Index 700-101

Typical Sections for Placement of Single and Multi-Column Signs

COMMENTS AND RESPONSES

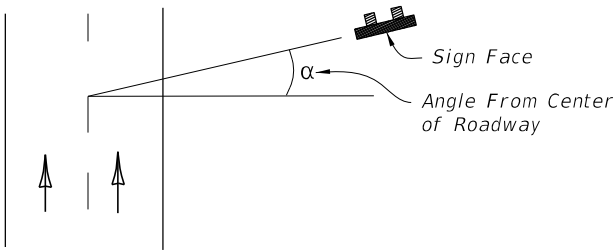
COMMENT: Sidewalk Detail: Since a single-column cantilever ground-mounted sign is shown, the maximum vertical clearance should be 9'-0"', as indicated in the Typical Section on Ind. 700-011, sheet 1 of 2.

RESPONSE: Thank you for the comment. The details for the shared use path and the urban side path will be updated to 8' minimum.

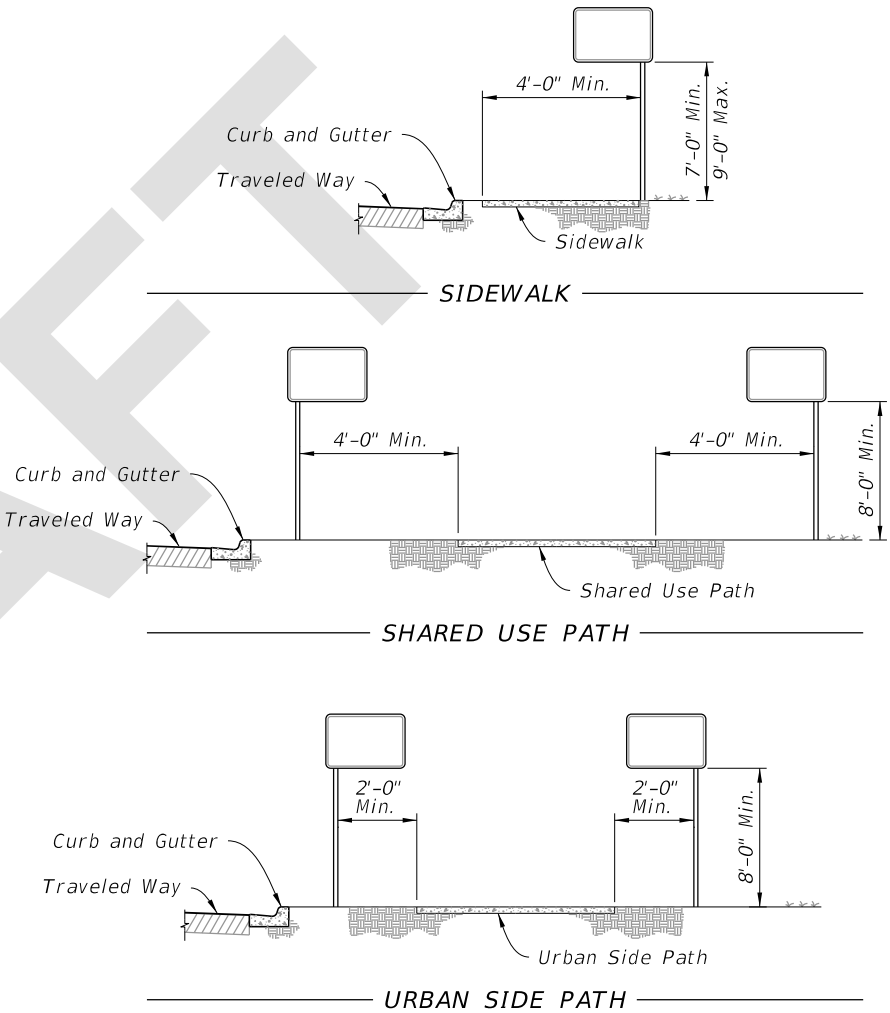
COMMENT: Sidewalk Detail: Since a single-column cantilever ground-mounted sign is shown, the maximum vertical clearance should be 9'-0"', as indicated in the Typical Section on Ind. 700-011, sheet 1 of 2.

COMMENT: Shared Use Path Detail: Since the SUP is utilized by bicyclists and micro-mobility users, who may off-track, it is recommended to provide a standard vertical clearance of 10' (8' minimum) for sign panels extending over both the SUP and its horizontal clear area. The same consideration should also be applied to Urban Side Paths. Note: if these recommendations are implemented, please update FDM Section 224.8 accordingly.

RESPONSE: This is correct. Thank you for catching this typo. The detail will be updated to show 9' max instead of 8'.

RESPONSE: Thank you for the comment. Currently our requirements state that the minimum clearance should be 8'. The detail will be updated to show this 8' clearance.
